# RENESAS TECHNICAL UPDATE

Product Category	MPU & MCU	Document No.	TN-16C-A240A/E	Rev.	1.00
Title	Deletion of Specifications and Errata for R32C/118A Group User's Manual: Hardware		Information Category	Technical Notification	
Applicable Product	R32C/118A Group	Lot No.	Reference Document	R32C/118A Group User's Manual: Hardware Rev. 1.10 (R01UH0215EJ0110)

This document describes deletion of specifications and errata for the R32C/118A Group User's Manual: Hardware, Rev. 1.10.

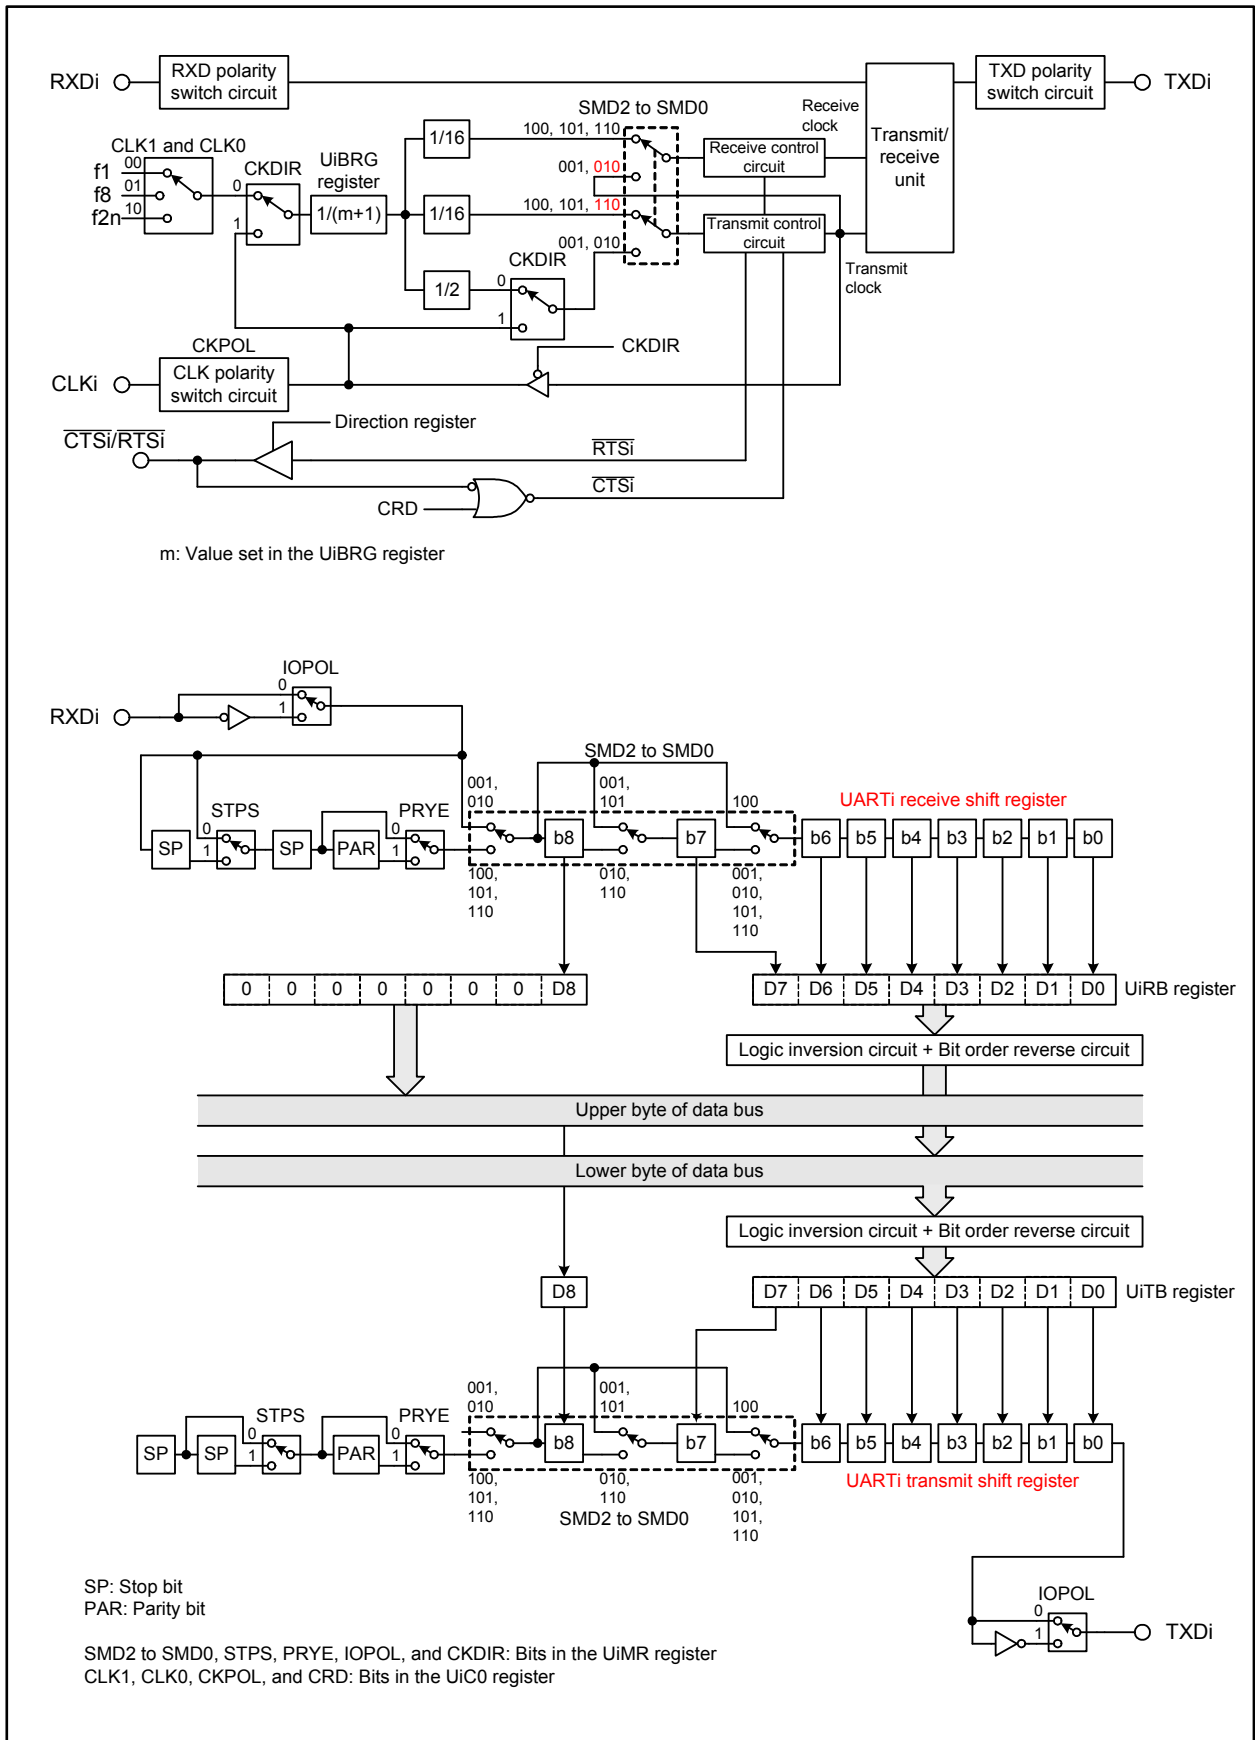
- Page 235 of 639, bit symbol “TAiS” in the Function column for the MR2 bit in Figure 16.16 is corrected as follows:

“TAiOS”

Transmit timing (when selecting an internal clock)

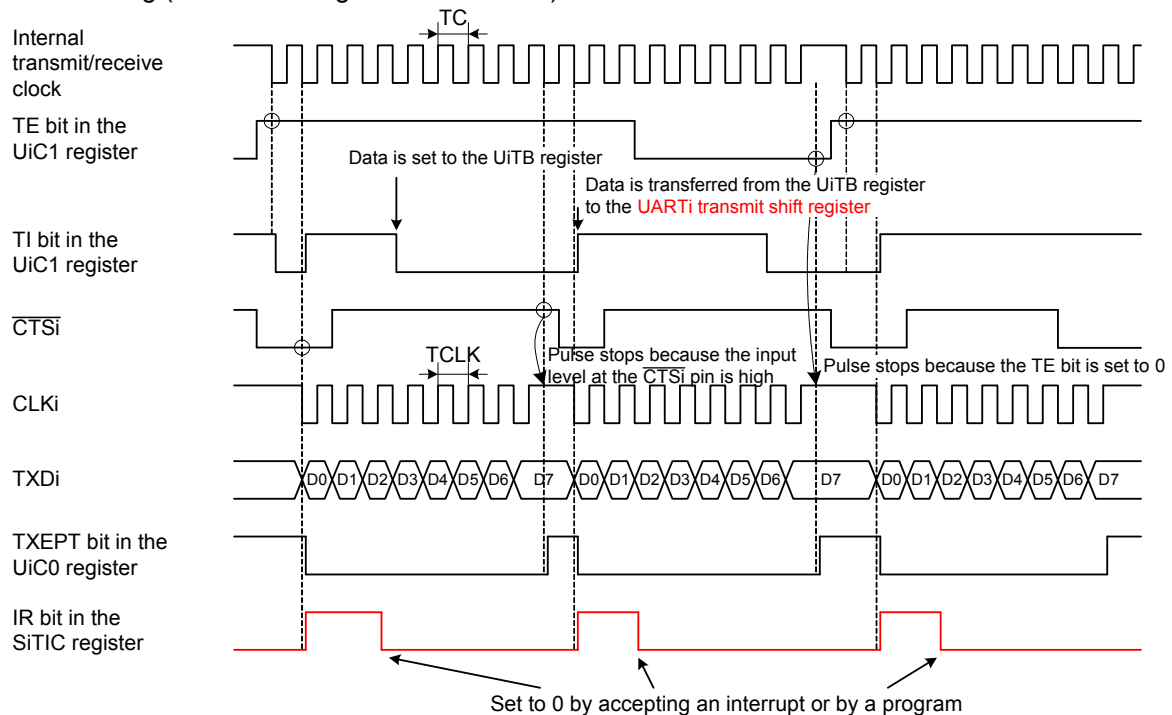
- Page 279 of 639, expression “baud rate generator count source” in the function of bits DL0 to DL2 in Figure 18.13 is corrected as follows:  
 “count source for the UiBRG register”
- Pages 286, 287, 294, 295, 304, 314 of 639, descriptions in Function of the UiBRG register in Tables 18.3, 18.4, 18.6, 18.7, 18.10, and 18.15 are modified as follows:  
 “Set the divide ratio according to the bit rate”
- Pages 287, 295 of 639, description for (b7 to b4) to registers UiC1 and U78CON in Tables 18.4 and 18.7 is added as follows:  
 “(b7 to b4) Set the bits to 0000b”
- Page 288 of 639, waveform of the IR bit in Figure 18.21 is corrected as follows:

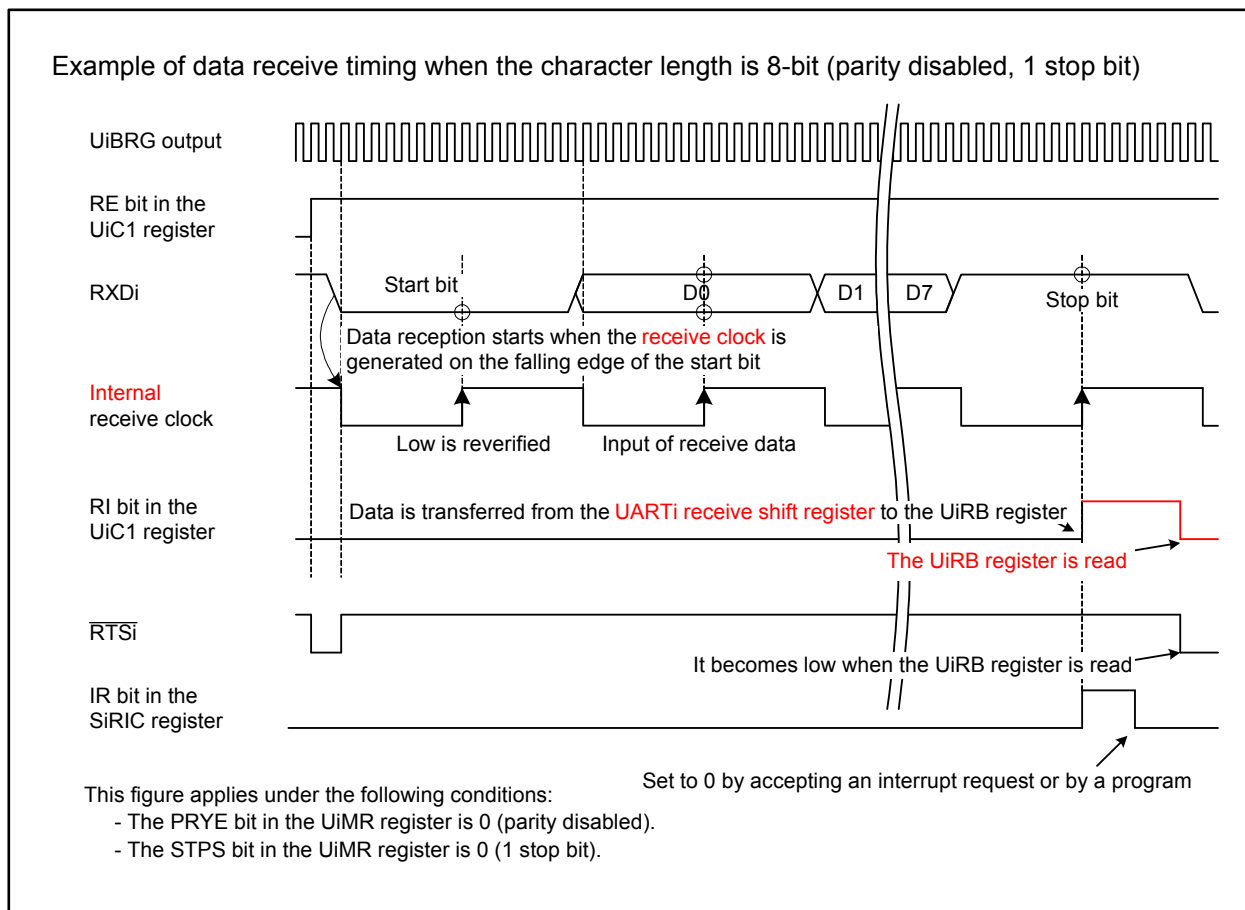
•Page 292 of 639, the following description is added to line 3 of 18.1.6:

“after the last bit is transmitted”
